April 3, 2014
NND-14-0188
10 CFR 50.90

Virgil C. Summer Nuclear Station (VCSNS) Units 2 and 3
Combined License Nos. NPF-93 and NPF-94
Docket Nos. 52-027 & 52-028

Subject: LAR 14-01 License Amendment Request:
Auxiliary Building Structural Floor Details

UFSAR Figure 3H.5-1 (Sheet 1 of 3) markups

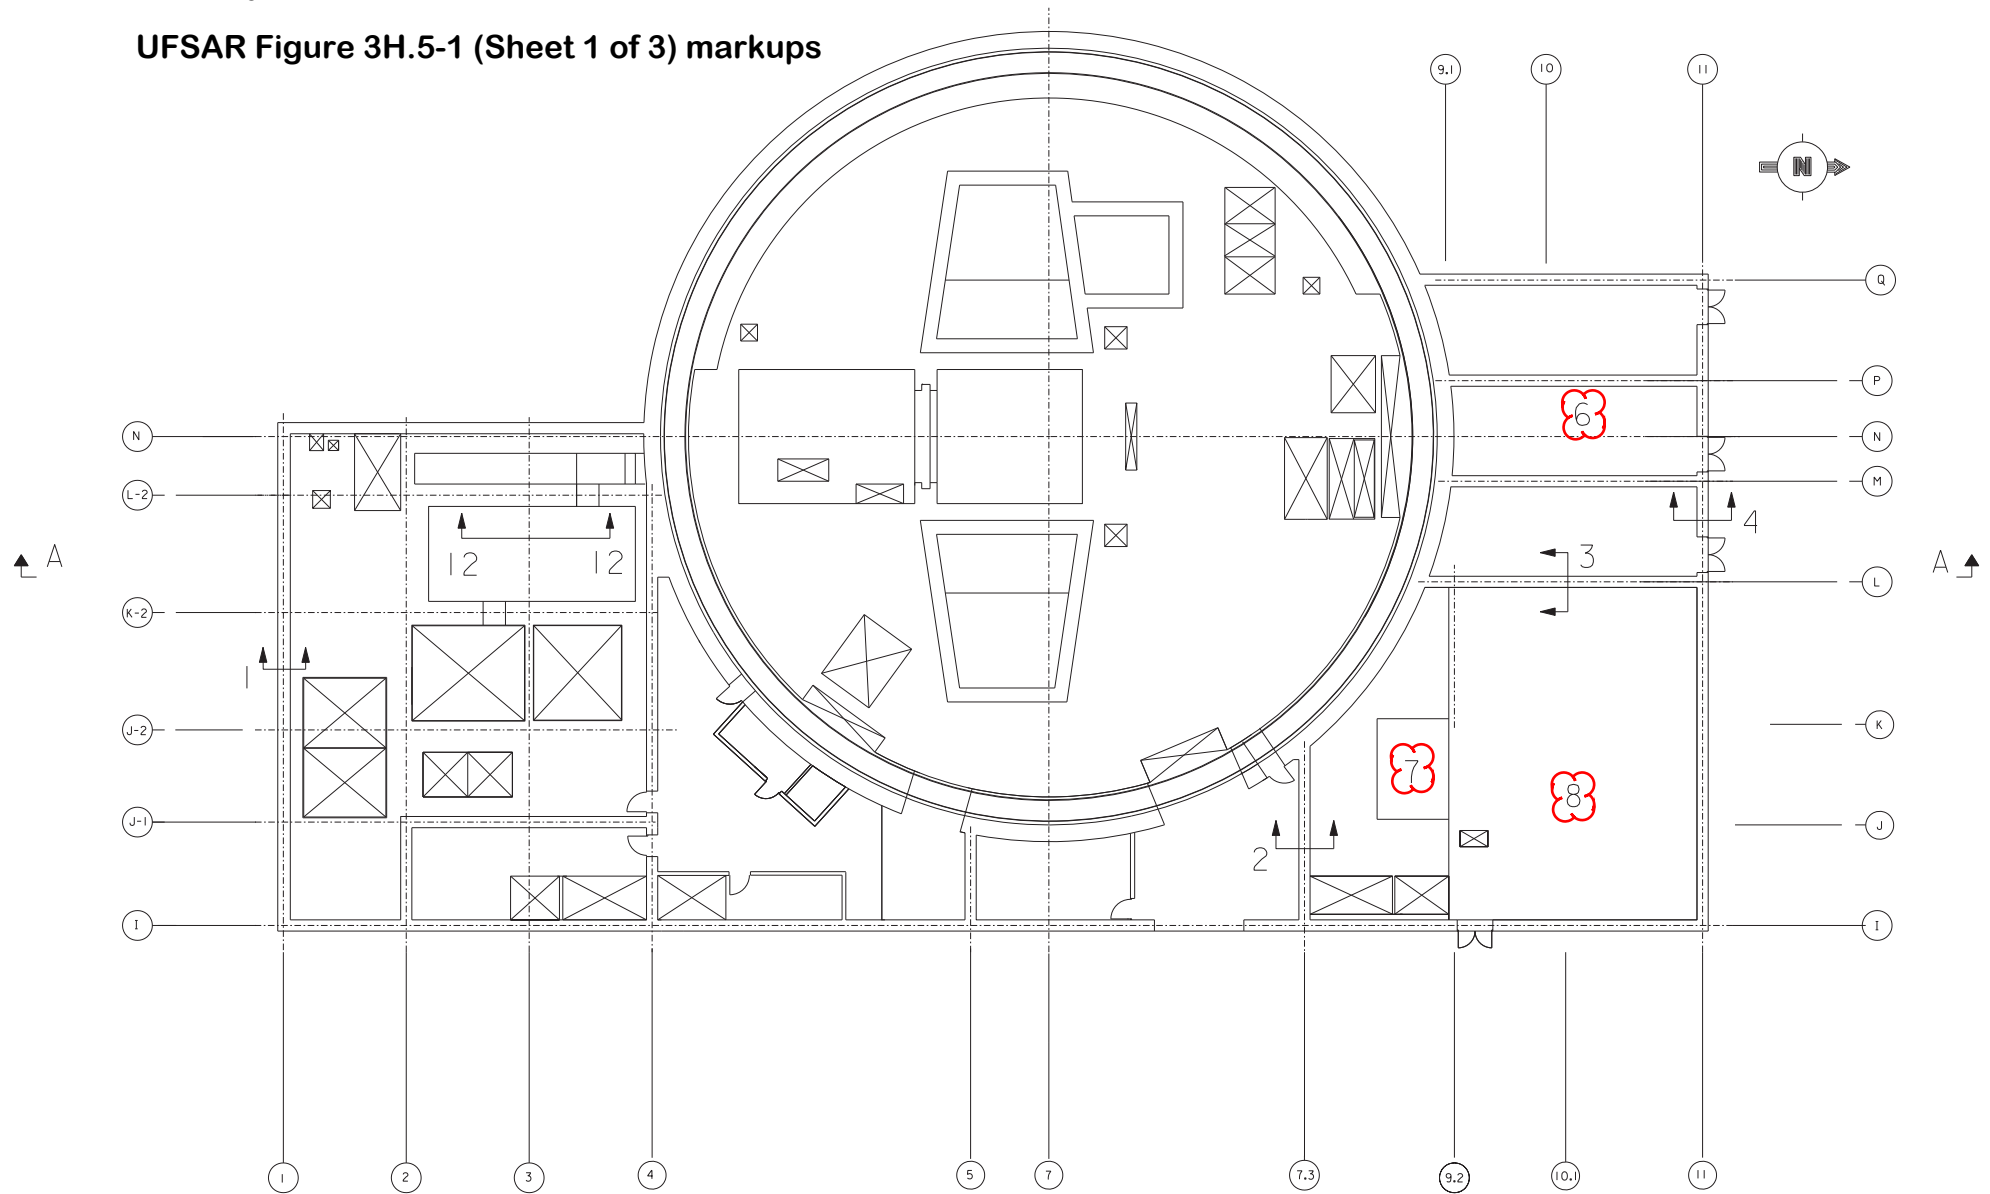
- H. UFSAR Figure 3H.5-1 is revised as follows:
 - 1. On Sheet 1 between column lines M and P change the “7” label to “6”
 - 2. On Sheet 1 between column lines I and L change the “9” label to “8”

- 3. On Sheet 1 between column lines 7.3 and 9.2 change the “8” label to “7”
 - 4. On Sheet 2 Move the arrows for Item 5 to near the intersection of wall N and the shield building cylinder wall.

5. On Sheet 2 between column line N and K-2 change the "6" label to "5"
6. On Sheet 3 at elevation 135'-3" change the "7" to "6"
7. On Sheet 3 at the intersection of the shield building roof and the outer tank wall change the "10" label to "9"
8. On Sheet 3 at the intersection of the shield building roof and the inner tank wall add a circle and label it "10"

The labels for the designation of the critical sections on UFSAR Figure 3H.5-1 are changed to match the item numbers in the list in UFSAR Subsection 3H.5.1. A new label for Item 10 is added to the figure.

The change to Figure 3H.5-1 is an administrative change so that the labels on the figure conform to the Item numbers in the list in UFSAR Subsection 3H.5-1. This change does not change the definition of critical sections, technical information, design requirements, or conformance with regulatory information.

UFSAR Figure 3H.5-6 markups

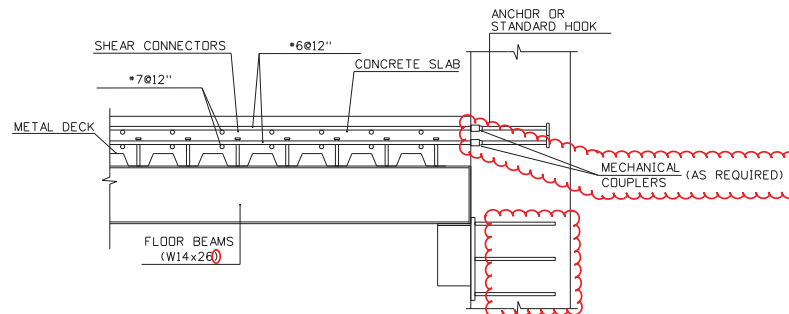
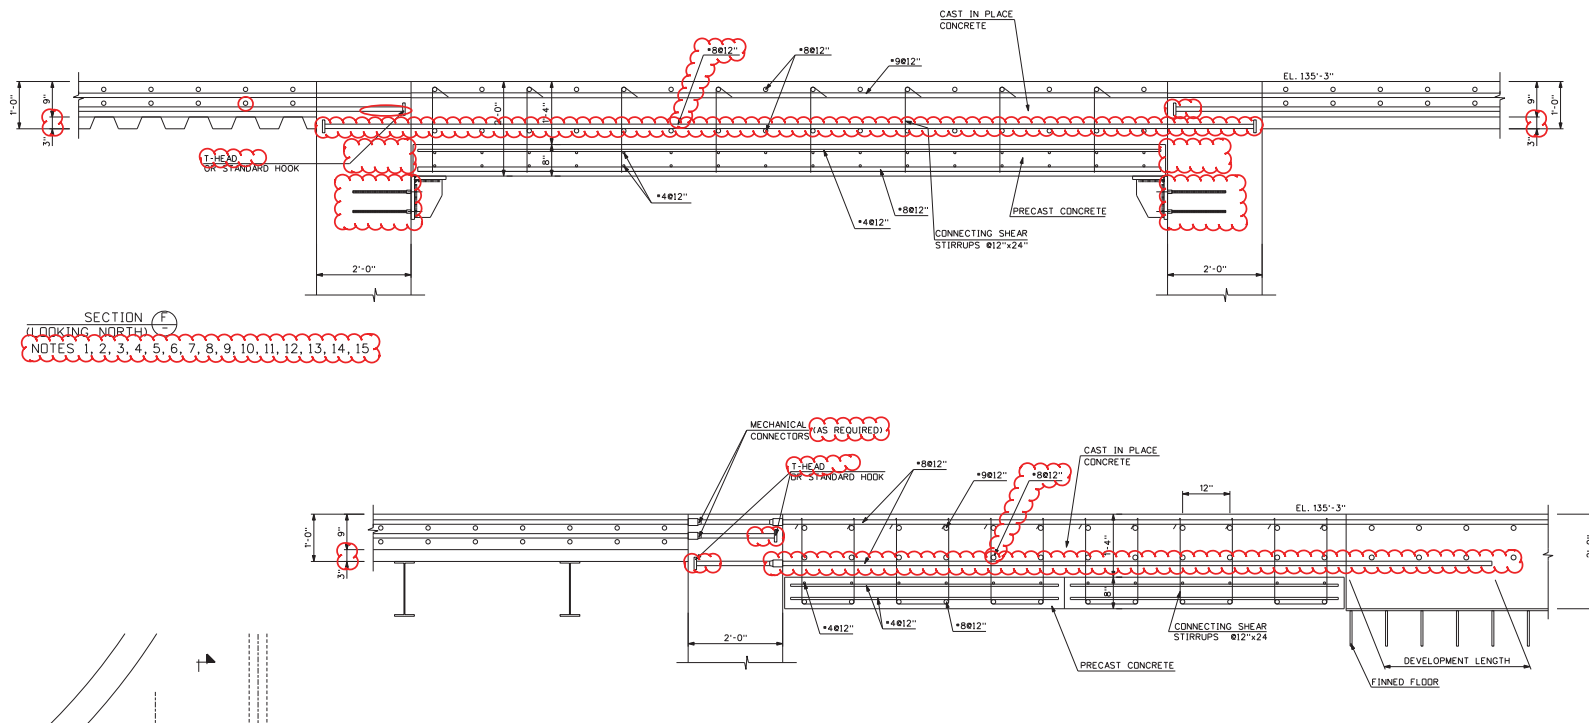
I. UFSAR Figure 3H.5-6 is revised as follows:

1. In Section A-A; Remove the "TYP." from the W 14x26 floor beam designation consistent with adding the notes
2. Revise the representation of the beam support to show deformed wire anchors embedded in the wall instead of headed studs.

3. In Section A-A, add a designation "Mechanical Couplers (As Required)" to the reinforcement couplers shown at the interface of the floor and wall
4. To the Label "PLAN VIEW" add "Notes 1, 3, 6"

5. To the Label "SECTION A-A" add "Notes 1, 2, 3, 4, 5, 6, & 7"
6. Move note 1 to the new list of notes and renumber to Note 2.
7. Add notes 1 and 3 through 7 to the figure. Renumber current note 1 to note 2.

Changes to UFSAR Figure 3H.5-6 remove the designation of the floor beam size as typical (TYP). The representation of the beam supports is changed to show use of deformed wire anchors embedded in the concrete. Notes are added to define the variations in other similar floor sections from the critical section design shown in the figure. The notes are described below in the Licensing Basis Change Description. The design of the critical section depicted in UFSAR Figure 3H.5-6 is unchanged.

Notes 1 and 3 through 7 are added. The current note 1 is renumbered to note 2.

UFSAR Figure 3H.5-8 markups

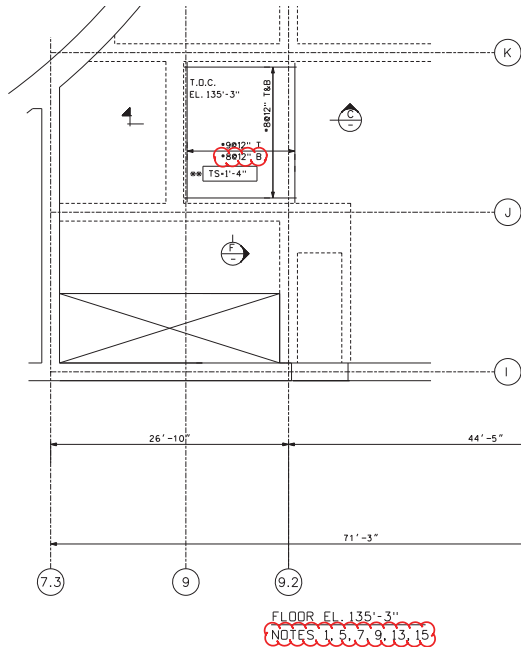
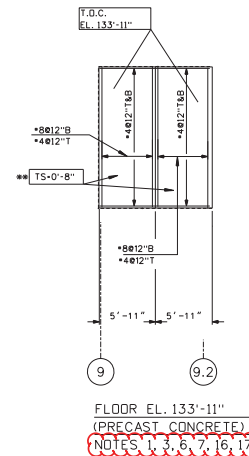
J. UFSAR Figure 3H.5-8 is revised as follows:

1. In Section F Looking North, replace the bottom #8@12" reinforcement bar extending into the walls with a bar that is contained within the precast panel.

2. In Section F Looking North, add a #8@12" reinforcement bar extending into the walls with headed reinforcement to the lower portion of the cast-in-place concrete. Add a label to this bar identifying the #8 @ 12" reinforcement arrangement.

3. In Section F Looking North, extend the length of the reinforcement bars terminated with headed reinforcement
4. In Section F Looking North, on the left side of the section view, replace "Anchor Plate" with "T-Head"

5. In the floor in the left side of the Section F View shift the misplaced small circle representing a north south reinforcement bar to the correct location above the east west rebar.

6. At each end of the Section F View the drawing convention to define the 3" distance is changed to move the arrows.
7. In Section F Looking North, revise the representation of the panel support to show deformed wire anchors embedded in the wall instead of headed studs.

8. To the Label "Section F Looking North" add "Notes 1, 2, 3, 4, 5, 6, 7, 8, 9, 10, 11, 12, 13, 14, 15"
9. In Section C Looking West, extend the length of the reinforcement bars terminated with headed reinforcement

10. In Section C Looking West, add designation of perpendicular longitudinal reinforcement above lower reinforcement bar in cast-in-place concrete and add arrow from "#8@12"" to rebar.

11. In Section C Looking West, replace "Anchor Plate" with "T-Head"
12. In Section C Looking West, add "(As Required)" to the designation "Mechanical Couplers" for the reinforcement couplers shown at the interface of the floor and wall

13. At the left end of the Section C View, the drawing convention to define the 3" distance is changed to move the arrows.

14. To Label "Section C Looking West", add "Notes 1, 2, 3, 4, 5, 6, 7, 8, 9, 10, 11, 12, 13, 14, 15"

15. In FLOOR EL. 135' 3" view, add "#8@12 B" for Bottom rebar.

UFSAR Figure 3H.5-8 is revised to change the representation of the flexural reinforcement design shown in the figure. The original figure shows reinforcement extending from the precast panel into the adjacent wall. This design is changed to support construction sequencing in which the concrete for the walls is placed before the precast panel is put in place. The figure is changed to show the reinforcement terminating within the precast slab and reinforcement added to the bottom of the cast-in-place portion. This additional reinforcement in the cast-in-place portion extends into the wall. The figure is also changed to fix discrepancies with drawing convention to show thicknesses in adjacent floors. The representation of the panel supports is

changed to show use of deformed wire anchors embedded in the concrete. In the plan view of the floor the bottom reinforcement (#8@12") is added. Notes are added to define the variations in other similar sections from the critical section design shown in the figure. The notes are described below in the Licensing Basis Change Description.

UFSAR Figure 3H.5-8 is also changed to modify the location of the T-Heads on headed reinforcements to be consistent with the criteria for development of headed reinforcement. The description on the figure for the anchoring of reinforcement is changed from Anchor Plate to T-Head to accurately reflect the use of headed reinforcement. A note referring to UFSAR Subsection 3.8.4.4.1 for the requirements for development of headed reinforcement is added to the figure. These criteria use ACI 318-11, Section 12.6 requirements and have been previously approved and incorporated into the licensing basis as part of the license amendment to include the use of headed reinforcement above the basemat. UFSAR Subsections 3.8.3.5, 3.8.4.4.1, and 3.8.4.5.1 of the licensing basis were previously revised with a license amendment request to incorporate these criteria. See SCE&G COL Amendments 2 and 5 (Adams Accession Numbers ML13056A183 and ML13149A314, respectively). The figure is also changed for consistency with drawing conventions.

The proposed changes to the reinforcement in UFSAR Figure 3H.5-8 are incorporated to provide reinforcement in the cast-in-place concrete consistent with the analysis to resist the loads in the cast-in-place concrete without relying on the flexural reinforcement in the precast panels. The figure is also revised to make a minor change to be consistent with drawing convention. The revised design is in conformance with ACI 349. The drafting convention changes do not change design information or design requirements.

Notes 1 through 17 are added.
